# Technical Service Information

## FORD ATX HARSH 2-3 UPSHIFT

Figure 1

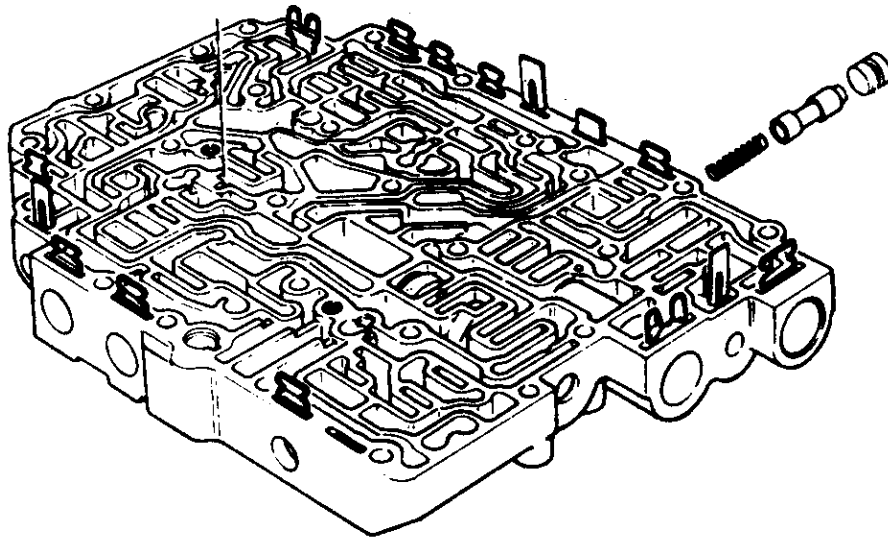
Soft 1-2 shift  
Harsh 1-2 shift

**CAUSE:** 1-2 capacity modulator valve spring calibration

Replace 1-2 capacity modulator valve spring with stronger spring.  
Replace 1-2 capacity modulator valve spring with weaker spring.
